STAFF REPORT

CERTIFICATE OF APPROPRIATENESS

Application Number: 2018-1001C **Property Location:** 50106 Bittersweet Trail

Corn Crib Project

Figure 10 - Foundation rot at shared wall with newer barn structure.

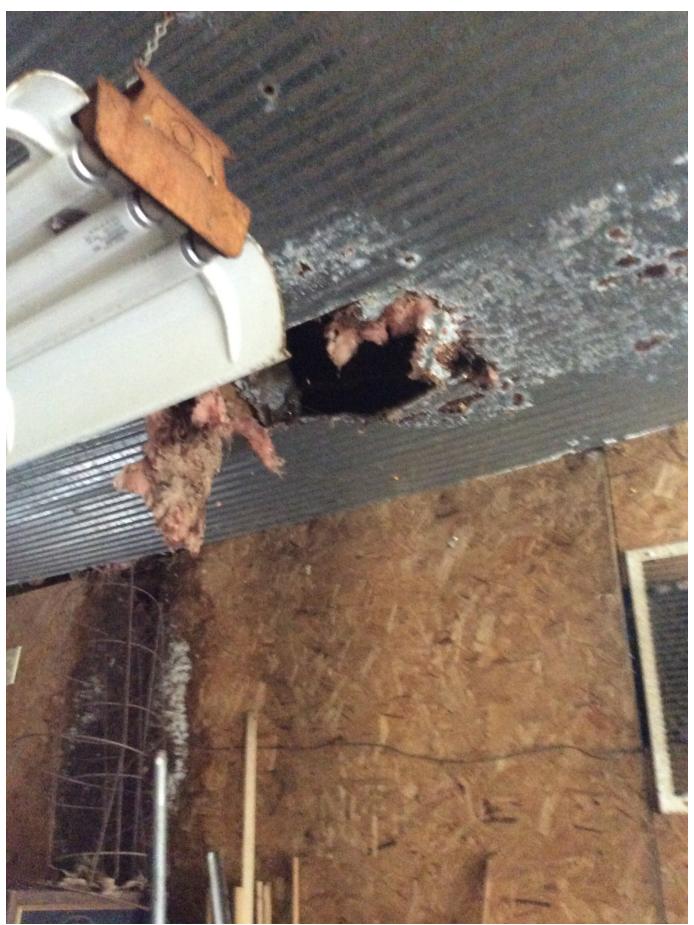
- -The wall in between this and the next section is an addition wall that is framed and on a combination of brick and toward the rear a cement curb. There is dry rot and termite damage along the entire bottom of this wall. Reference *Figure 10*.
